Re Land East of 1 To 25 Hayes Lane Slinfold West Sussex DC/25/2006

I write to object to the plan for 38 new houses.

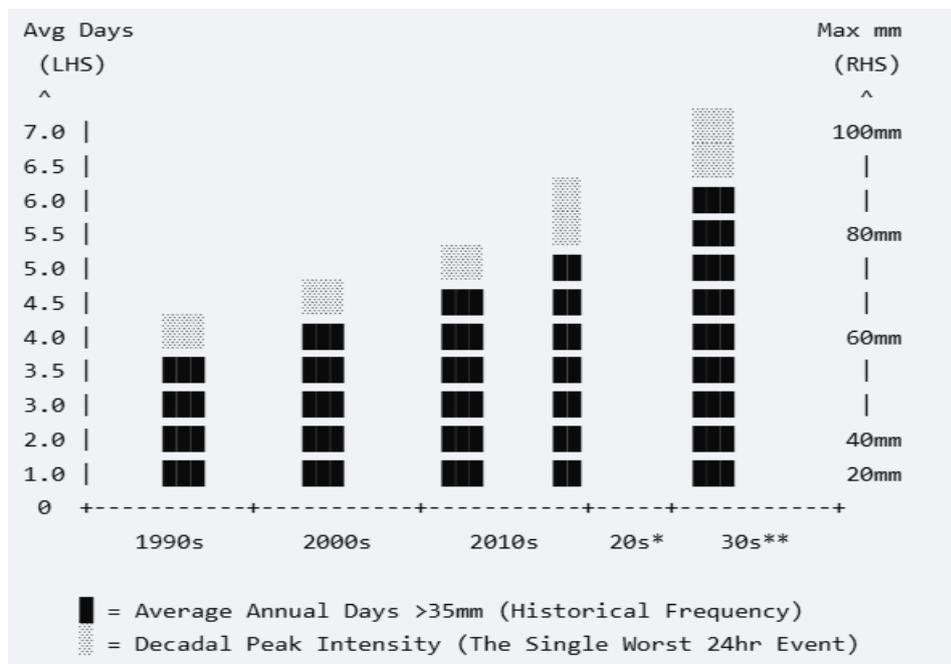
HDC must understand how the 'at capacity' situation has happened in advance of climate change predictions. The rainfall locally in Slinfold has been on a sharply increasing trend as shown in the below graph which uses data from the Itchingfield rainfall monitor station just 2miles from Slinfold village. The trend already causes regular road flooding in Slinfold which is now in a vulnerable state ahead of further climate induced rainfall increases.

The below graph shows the average number of heavy rain days (over 35mm in one day) per year over the last few decades. In the 1990's Slinfold had 3 days on average per year, this has risen by 100% to 6 days per year in the 2020's. The added issue to be understood is the max storm intensity has also increased from 52mm in the 1990s to 79mm in the 2020s. This over and above GovUK forecasting but which is then used below to project the values into the 2030s.

HDC must examine the 'Climate Change Allowances' used in the developer's drainage strategy. Standard planning models typically apply a 40% uplift to historical data to account for future intensity. However, the Itchingfield (E9290) rainfall gauge records prove that Slinfold has already moved from a 1990s peak intensity of 52.4mm to a 2020s peak of 79.5mm—a real-world increase of over 51%. This confirms that the climate change intensity shift is occurring faster than current planning guidance assumes. By using standard 40% allowances, the developer is effectively under-engineering the SuDS (Sustainable Drainage Systems) for a 2026 reality, creating a significant and quantifiable risk of downstream flooding for the existing residents of Slinfold."

Therefore I urge the council to refuse this application until drainage infrastructure is upgraded in accordance with a full, independent hydraulic catchment study of the Slinfold ditch/drainage network, which accounts for the 2026 climate reality rather than outdated historical averages.
